Montgomery Planning

MCPB
Item No. 4
Date: 11/12/2020

Avondale, Sketch Plan No. 320200050 and Preliminary Plan No. 120200220

Description

Figure 6 – Sketch of consolidated entrance for loading/trash/parking garage

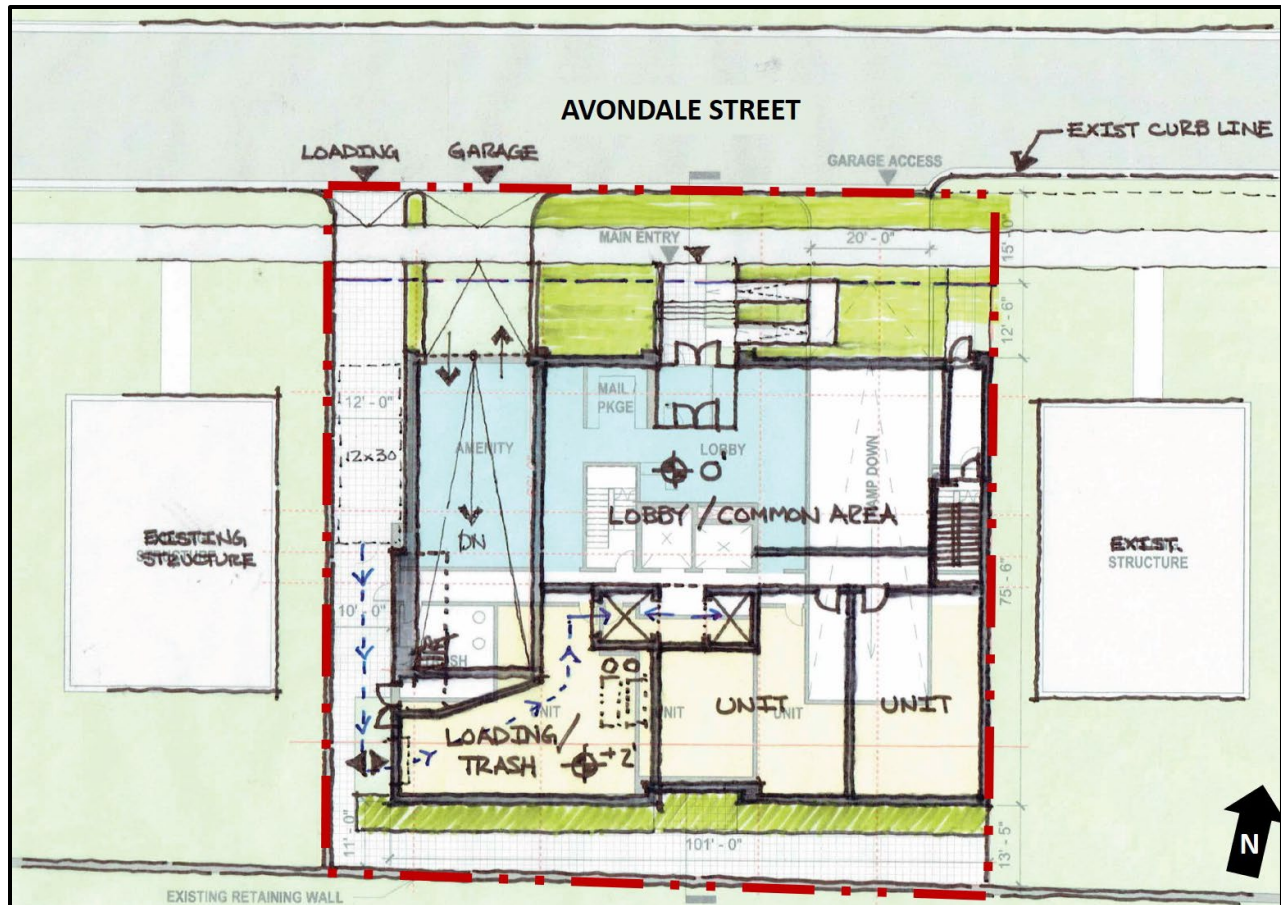
- a. Further refine the design of the consolidated entrance for loading/trash and the parking garage to reduce conflicts between pedestrians and motorists; and
- b. If public open space is provided for the purposes of public benefit points, further refine proposed design to ensure it is open and welcoming to the public.

Originally, the Applicant proposed two vehicular curb cuts along Avondale Street; one for trash and loading operations and another for access to the parking garage. Staff and the Applicant worked to consolidate these curb cuts to reduce impacts the public realm and improve the future walkability of the street, as shown in Figure 6 below. The Project will be conditioned to show a consolidated access point at the time of Certified Preliminary Plan with further detail at Site Plan review.

Figure 7 - Pedestrian and Vehicular Circulation

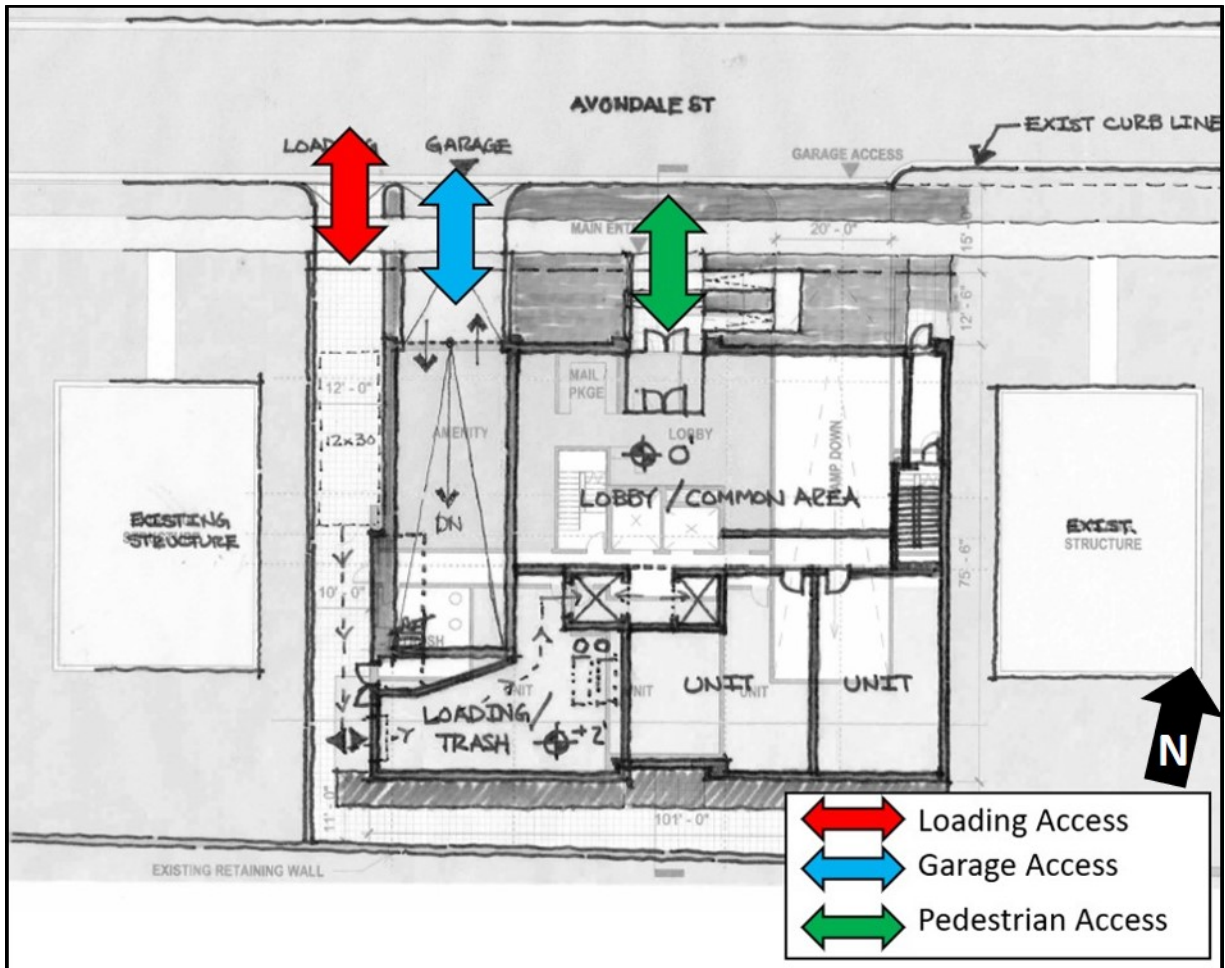
Vehicular access to the Site is on the west side of the building. Loading and garage access will be accommodated via a consolidated curb cut to reduce conflicts with pedestrians and motorists (Figure 7). The access configuration will be further refined at the time of Site Plan.

- b. Update all plan drawings to be consistent with the consolidated loading and garage access point on the west side of the Site.
